- 4. Ruth Haven Estates Debby's Addition; KPB File 2025-167**
Edge Survey & Design / Hansen
Location: Spruce Haven Street & Onyx Avenue
Nikiski Area

**ITEM #4 - PRELIMINARY PLAT
RUTH HAVEN ESTAETS DEBBY'S ADDITION**

KPB File No.	2025-167
Plat Committee Meeting:	January 26, 2026
Applicant / Owner:	Debra M. Hansen of Kenai, Alaska
Surveyor:	Jason Young, Edge Survey and Design, LLC
General Location:	Onyx Avenue and Spruce Haven Street off Miller Loop Road, Nikiski

STAFF REPORT

RUTH HAVEN ESTATES

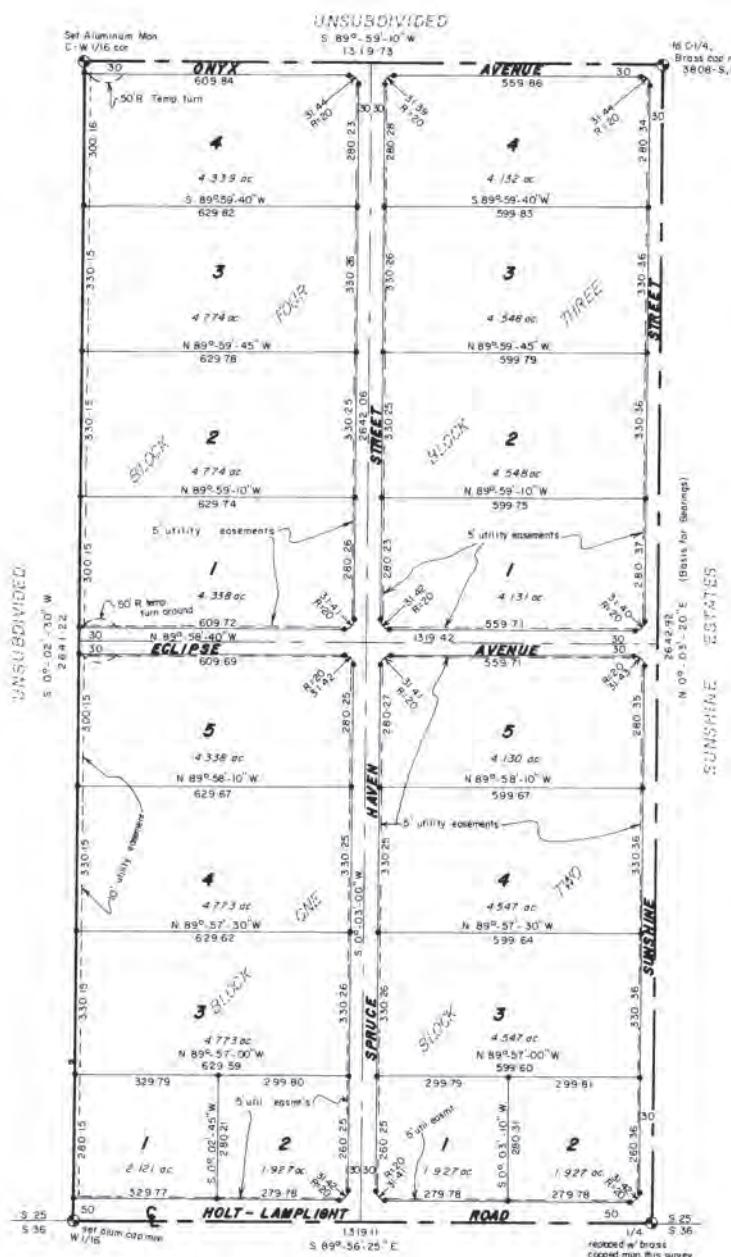
Ruth Haven Estates (KN 76-131) also included a 50-foot-radius temporary turnaround at the northwest corner of former Lot 4. In 1968, KPB subdivision design requirements (20.15.075(19)) required temporary dead end streets at the end of stub streets intended for future connection to adjoining areas. Current code (KPB 20.30.100) states that Temporary turnarounds and self-vacating turnarounds shall not be granted or reserved on plats.

PRELIMINARY PLAT

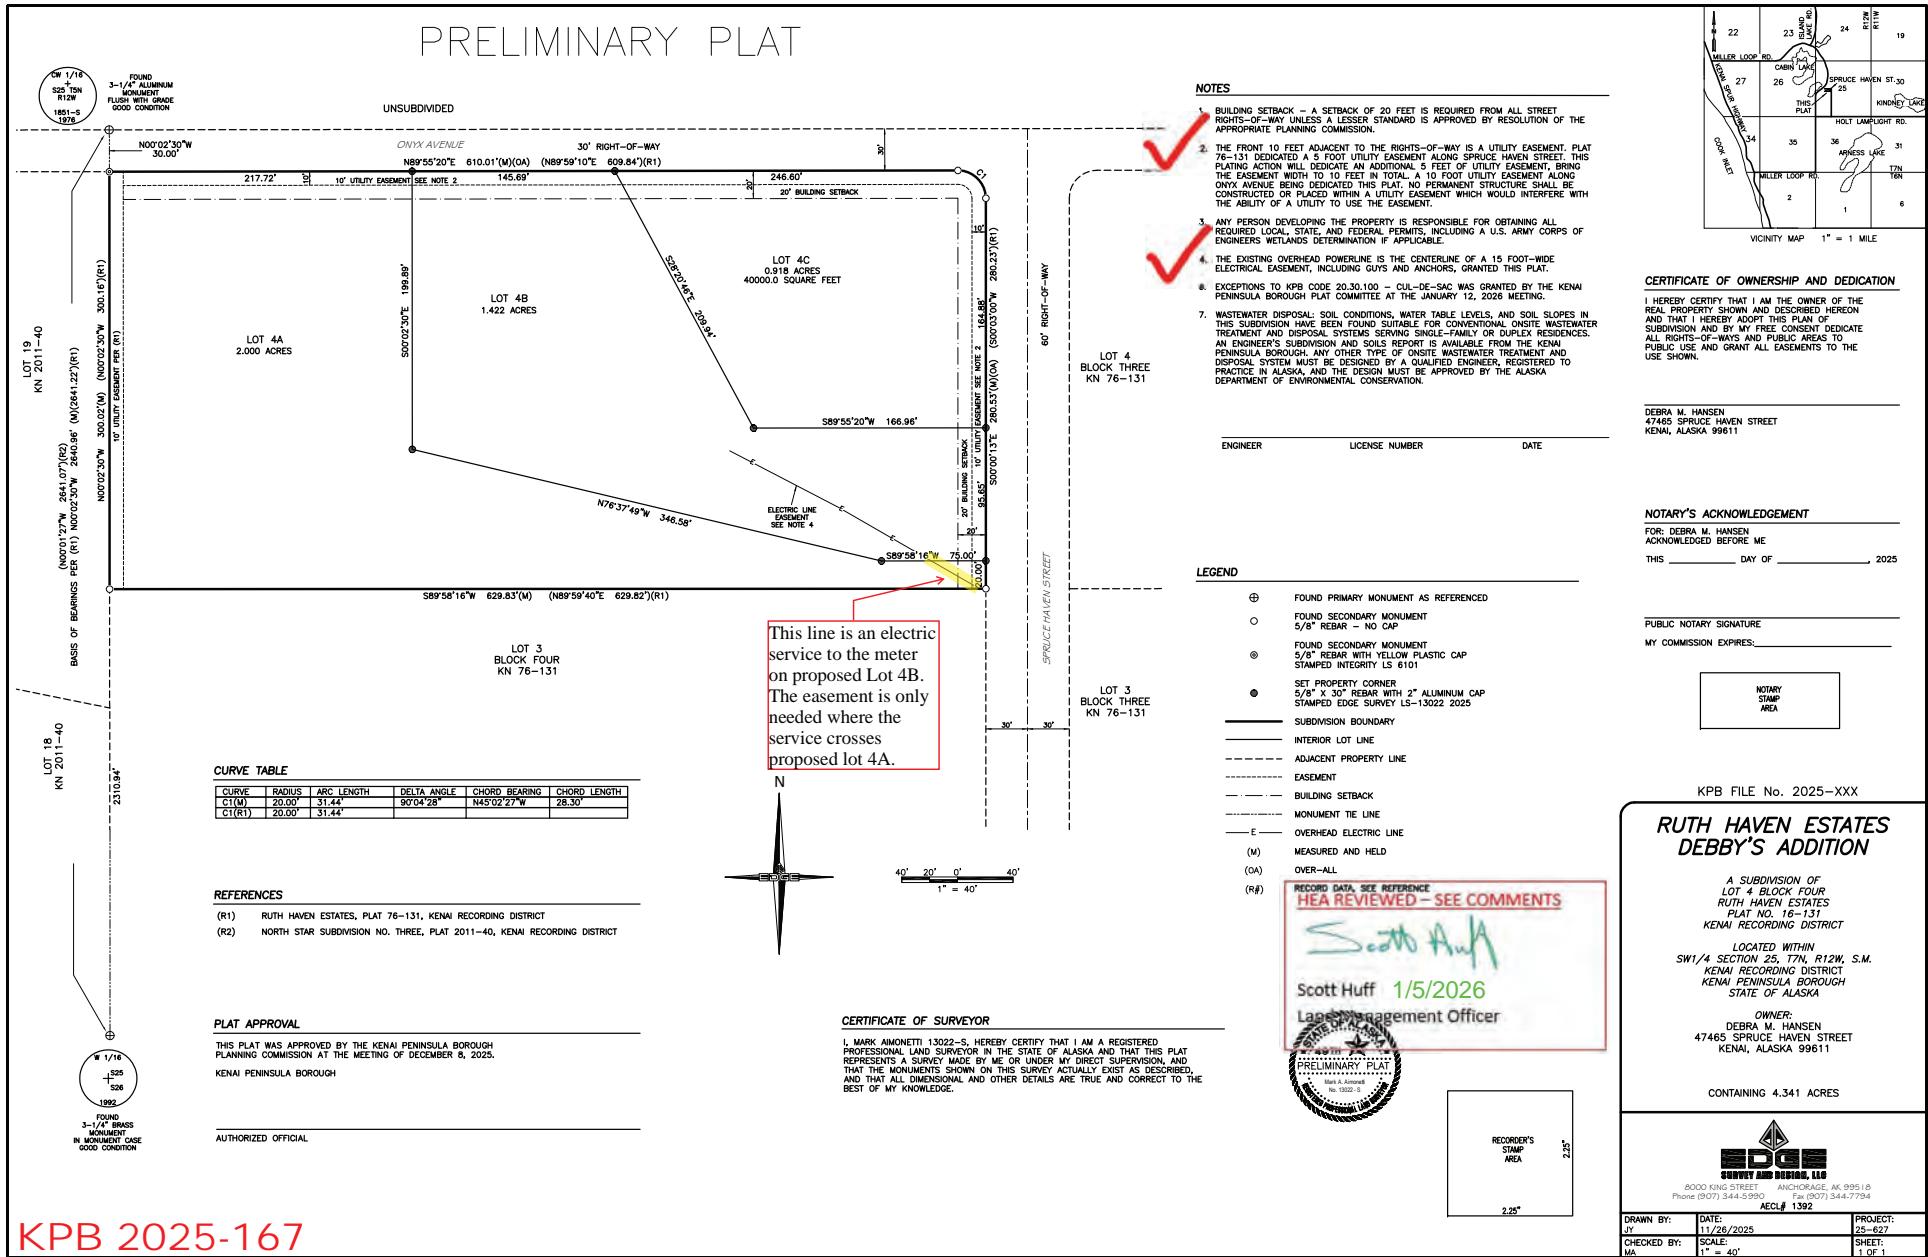
In 2011, North Star Subdivision No. Three (KN 2011-40) dedicated the west extension of Onyx Avenue, establishing the intended future connection. The existing rights-of-way provide sufficient legal access for surrounding properties and emergency response. **Staff recommends** that the Plat Committee concur that a right-of-way vacation petition is not required to remove the temporary turnaround, and that the 50-foot-radius temporary turnaround may be removed through this platting action. **If approved**, a plat note should be added stating that the 50-foot-radius temporary turnaround shown on the KN 2011-40 plat was removed in accordance with KPB 20.30.100, as approved by the Plat Committee on January 26, 2026. The turnaround should be hatched, and a label should be provided referencing the corresponding plat note.

No structures are depicted on the submitted preliminary plat. According to available data, multiple structures are located on the subject property, situated on the eastern portion and near the center of the former Lot. Upon finalization of the plat, it appears these structures will be located on proposed lots 4A and 4B. A driveway appears to extend from Spruce Haven Street to access proposed Lot 4B. Based on staff calculations, this driveway does not appear to encroach into the proposed area of Lot 4A. **Staff recommends** the applicant provide clarification with the final plat submittal regarding whether the driveway encroaches, and if so, how the encroachment will be addressed.

No wetlands affect the parcel according to the KPB GIS KWF Wetlands Assessment Layer. **Staff recommends** that plat note #3 be removed from the final plat.

Proposed Lot 4A is a flag lot, with the access portion measuring 20 feet in width and 75 feet in length, meeting the requirements of KPB 20.30.190 (B). The lot design allows for double-frontage, and exceeds the minimum depth width required under KPB 20.30.230. **Staff recommends** that plat note #5 be revised to state: *No wastewater disposal or structures are permitted within the panhandle portion of flag lot 4A.*

Ruth Haven Estates (KN 76-131) granted a 5-foot utility easement along Spruce Haven Street and a 10-foot utility easement along the western boundary of former Lot 4. The proposed plat grants an additional 5-foot utility easement adjoining the existing easement, resulting in a total easement width of 10-feet. **Staff recommends** modifying plat note #2 to correct typos (*bringing* and *plattng*.) Additionally, **staff recommends** depicting and labeling the existing 5-foot easement on the plat with a reference to plat note #2.

HEA reviewed the preliminary plat and provided a modification to the electric line easement as depicted on proposed Lots 4A and 4B. **Staff recommends** revising the easement in accordance with the HEA review.

ENSTAR has requested an easement for an existing natural gas service line that crosses proposed Lot 4C to serve proposed Lot 4B. **Staff recommends** that this easement request be resolved with ENSTAR prior to final plat approval.

- o Modify the KPB File Number to 2025-167
- o Add the following plat note, "Acceptance of this plat by the Borough does not indicate acceptance of any encroachments."

- o Modify the legal description parent plat to *Plat 76-131*

- o Modify lake label from *Arness Lake* to *Salamatof Lake*

Drive for Lot 4B from Spruce Haven Street appears to be close to the lot line with 4A. Confirmation whether the drive encroaches to be submitted with final plat.

- Add 5-foot utility easement

- Within the Notary's Acknowledgement, modify the year to 2026.
- Within the Plat Approval, modify the meeting date to January 26, 2026.
